SUBJECT: Draft Roundtable Response Package to FAA Initiative Results to Address Noise Concerns

Re: *FAA Initiative Phase 1, SFO Airport/Community Roundtable Response*

San Francisco International Airport/Community Roundtable
Response to the FAA Initiative [DRAFT]

SSTIK Procedure and Flight Tracks

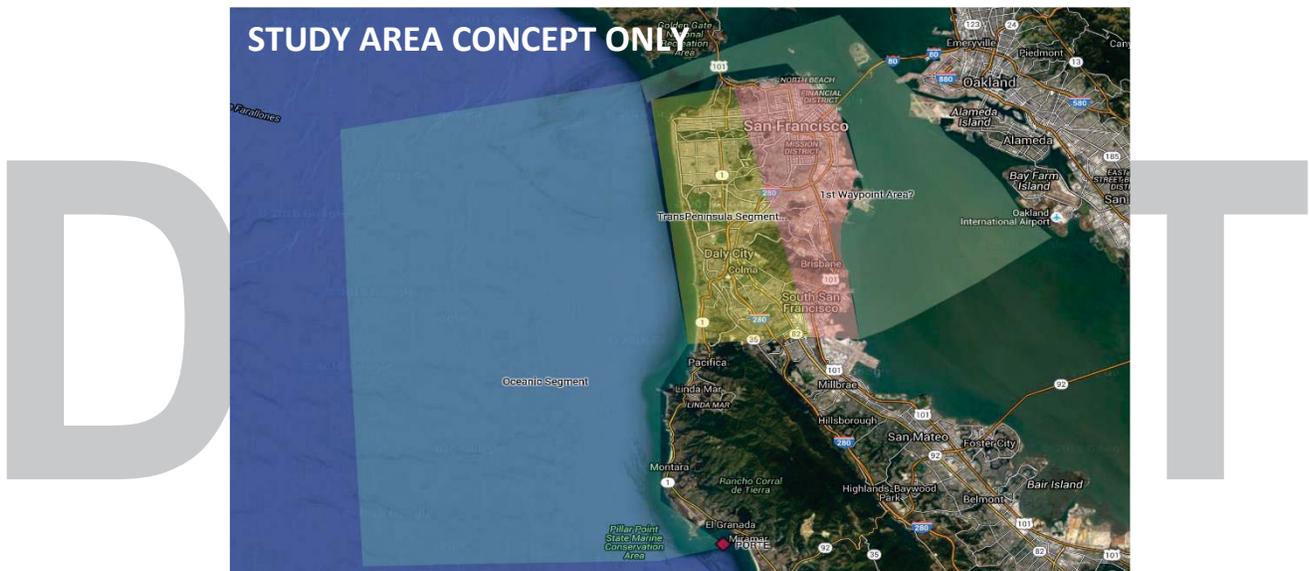
1. Move SSTIK waypoint north and east as much as feasible to allow maximum altitude gain before turning west to fly over land.

2. Determine the necessity for an additional waypoint on land after SSTIK to provide lateral path guidance to airplanes to reduce noise impact.

SSTIK Procedure Concept

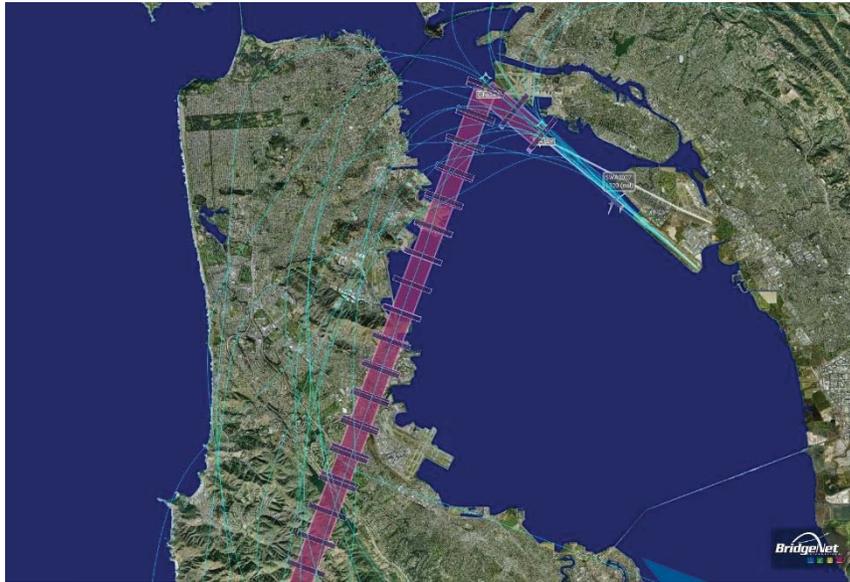
1. Design a new transition from the vicinity of SSTIK waypoint to PORTE waypoint or to a waypoint further south along the coast. It is suggested that the lateral path for this transition be researched and studied by dividing the lateral path into four or more suggested segments as follows and as suggested on the above graphic:
 - a. Green segment: Takeoff to SSTIK (or a revised location of SSTIK) or an additional Bay waypoint or out the Golden Gate Bridge.
 - b. Pink segment: Eastern portion of San Francisco and the north Peninsula.
 - c. Yellow segment: Western portion of San Francisco and the north Peninsula.
 - d. Blue segment: Pacific Ocean coastline to PORTE intersection or to a waypoint south of PORTE – remaining significantly offshore over the Pacific Ocean for the entirety of this ocean segment.

1. Work with the FAA to find an appropriate location for moving the SSTIK waypoint east and north of its current location so planes can fly over the Bay for a longer period of time, and thus increase altitude before heading west and flying over residential areas.
2. Explore feasibility of creating a waypoint to help guide planes over non-residential areas when they reach land (the peninsula).

3. Work with our local FAA officials to reduce vectoring and allow planes to fly the charted procedures when safety is not an issue.
4. Work with local FAA officials and airlines to encourage higher altitudes when flying over residential areas and the use of non-residential areas where feasible.
5. To monitor success, provide a monthly report indicating percentage of flights that achieve these stated goals.
6. Extensive long term collaboration will be required to initiate and develop the process of creating a new southbound destination transition from the SSTIK waypoint.

CNDEL Procedure and Flight Tracks

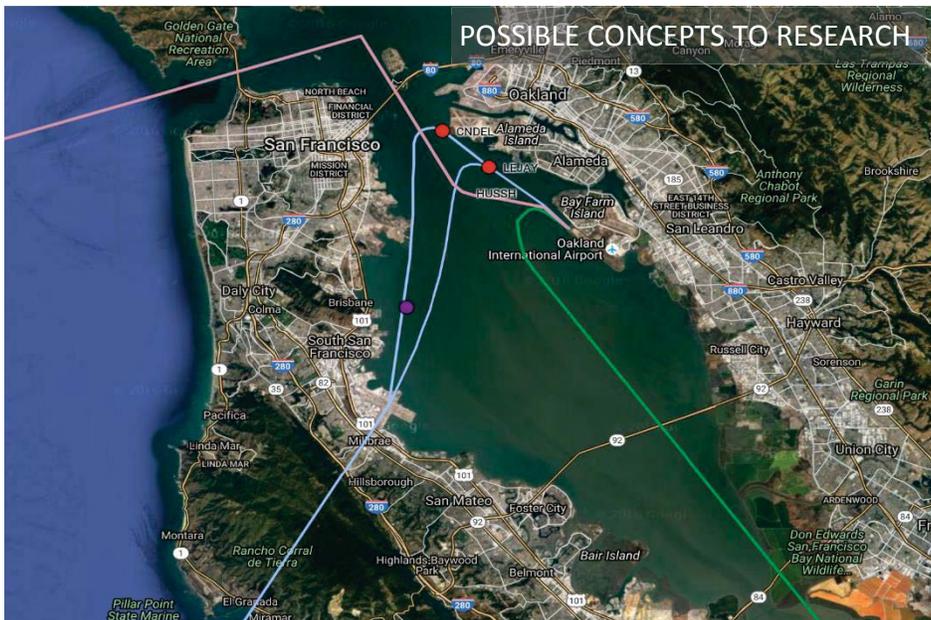
1. In the existing procedure, fly the planes on the charted CNDEL Departure so that they fly over the CNDEL waypoint and reduce impacts with SSTIK coming from SFO – reduce vectoring of both procedures. Aircraft should utilize the Bay to gain altitude before flying over populated areas.
2. Use the Bay and Pacific Ocean for overflight as much as possible. From the CNDEL waypoint, direct aircraft to a waypoint in the Pacific Ocean.
3. Increase more flights out the Golden Gate, especially at night.
4. Fly planes at a higher altitude over residential areas to reduce noise impacts.
5. Avoid assigning a southbound heading beyond PORTE, so that planes stay offshore longer.

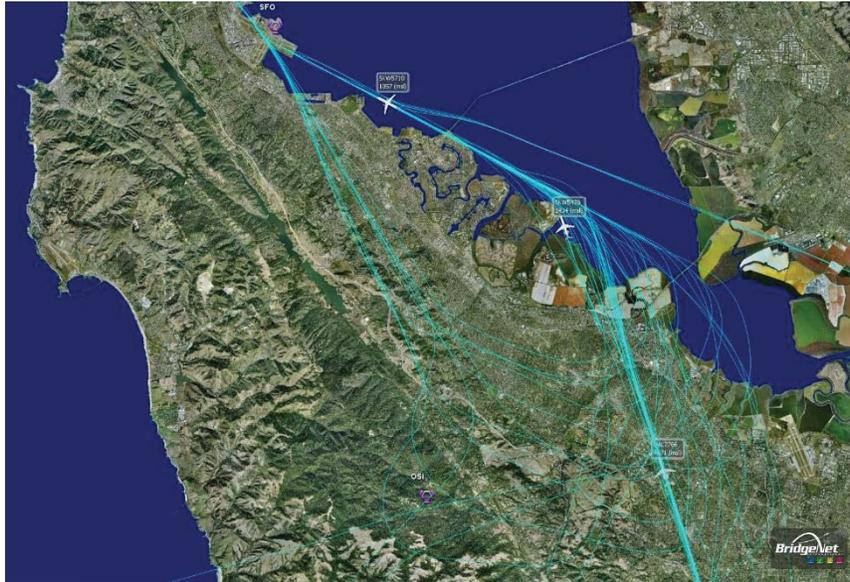
Any possible options for CNDEL southbound departures should be researched. Above are three possible concepts; there may be other concepts to be added to the research. PINK: flying over the waters of the Golden Gate to the Pacific Ocean. GREEN: turning south down the Bay; BLUE: over LEJAY or CNDEL to SFO Airport, then over Millbrae and Burlingame to PORTE waypoint.

1. The SFO Roundtable requests that the FAA work with the Roundtable to explore options for other “noise friendlier” departure paths for flights using the OAK CNDEL Departure, especially for CNDEL southbound flights. Such options might include (but are not limited to) flight over the waters of the Golden Gate to the Pacific Ocean or flight over the Bay to SFO and then over the Peninsula (primarily Millbrae and Burlingame) to PORTE or flight down the Bay as far south as feasible, or other options that may become known.
2. The SFO Roundtable requests comprehensive FAA data on flight paths and altitudes of flights flying the OAK CNDEL departures since its inception, as well as similar data from comparable historical departures that previously served the same kind of departure as the CNDEL from Runway 30 (previously Runway 29) with southbound and westbound destinations.

3. For whichever “noise friendlier” options are deemed feasible, the SFO Roundtable requests that the FAA provide appropriate noise modeling studies and other research to assist the SFO Roundtable in considering all factors in making a recommendation.
